Environmental Planning Commission

Agenda Number: 3
Project #: 2018-001577
Case #: SI-2024-00994
Hearing Date: August 15, 2024

Staff Report

Agent	Dekker
Applicant	City of Albuquerque Aviation Department
Request	Double Eagle II Airport Site Plan – EPC
Legal Description	All or a portion of Tract A-1, Plat of Tract A-1 & Tract L-1, Parcels 1-5, Double Eagle II Airport; Tract C and Parcel-1 Tract M Bulk Land Plat of Double Eagle II Airport & Adjacent Lands; the Southeasterly Portion of Tract D-1-A-1, Tract D-1-A-2, and Tract S-1-A Plat of Tracts D-1-A-1, D-1-A-2, & S-1-A of Amended Bulk Land Plat for Aerospace Technology Park; Tract E, F, and K Bulk Land Plat of Double Eagle II Airport & Adjacent Lands; Tract N-1 and Tract N-2 AKA Parcel 4 Bulk Land Plat of Tracts N-1, O-1, & N-2 Parcels 1, 2, 3, & 4 Double Eagle II Airport & Adjacent Lands; and Tract S-2 Bulk Land Plat for Aerospace Technology Park, Tracts D & S of Double Eagle II Airport & Adjacent Lands
Location	7401 Paseo Del Volcan NW, NW of the Atrisco Vista Blvd and Shooting Range Access Rd intersection

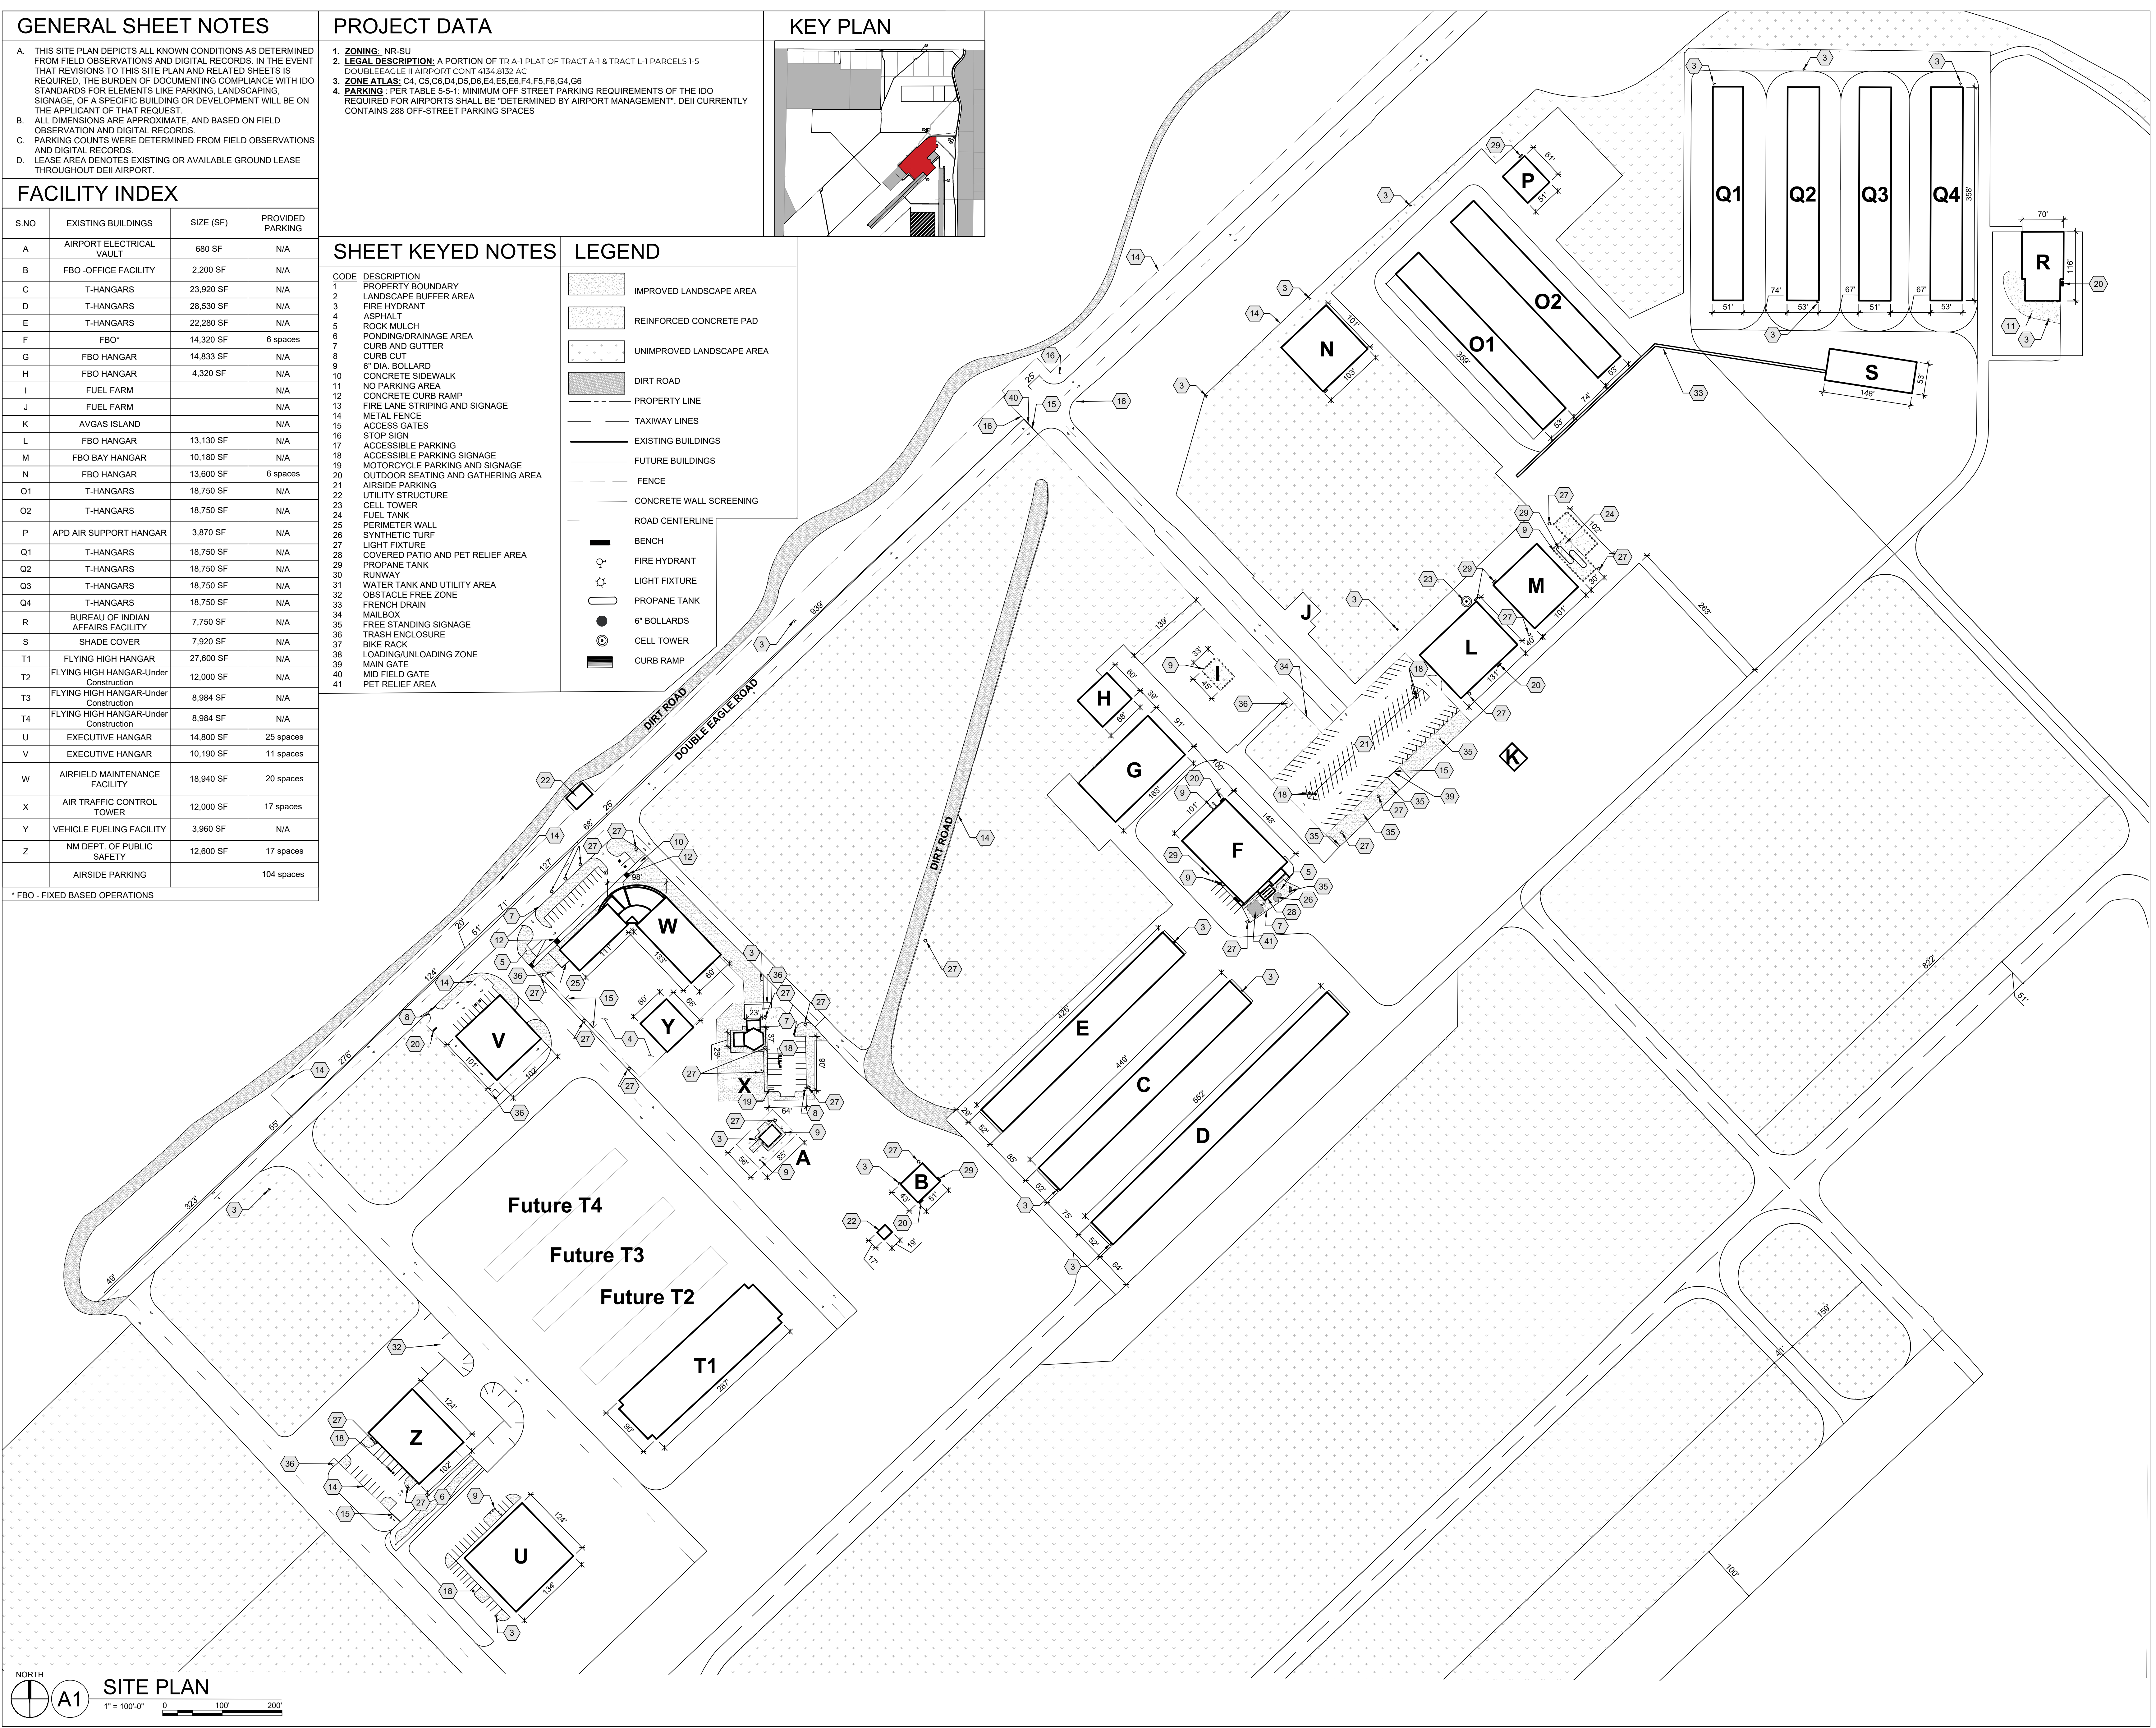
5. Site Plan:
 - A. G5 shall be added to the Zone Atlas description for all pages (e.g., SDP1.2).
 - C. Zoning descriptions shall be indicated for each parcel outside of the DEII boundary on Sheet SDP1.1.

- D. A note shall be added to explain the Obstacle Free Zone on Sheets SDP1.2 and 2.1.
 - E. A keyed note shall be added for the diagonal (NW-SE) solid line running from the area with buildings Q1-4 and road on Sheet SDP1.2.

- G. Add sidewalks to Site Plan where appropriate with dimensions.
 - H. The existing fencing east and south of Building Z shall be added to Sheet SDP 2.1.

- I. The depicted parking spaces shall match the number of parking spaces provided in the Facility Index Table on Sheet SDP1.2.
 - J. Building S (Shade Cover) and Area/ Building Y (Vehicle Fueling Facility) shall be added to elevation drawings with complete dimensions.

- A. The storage building west of Building R shall be added to the proposed Site Plan, Sheet SDP1.2 with a Keyed Note.
- B. Dimensions for western and northern structure features of Building X shall be added to AE3.20 as seen on SDP1.2.
- C. The building height for the single-story portion of Building Z shall be added to Sheet AE3.21.
- D. Both (2) Utility Structures shall be depicted with dimensions on Sheet AE3.23 (Site Amenities).
- E. Wall mounted signage dimension shall be provided.
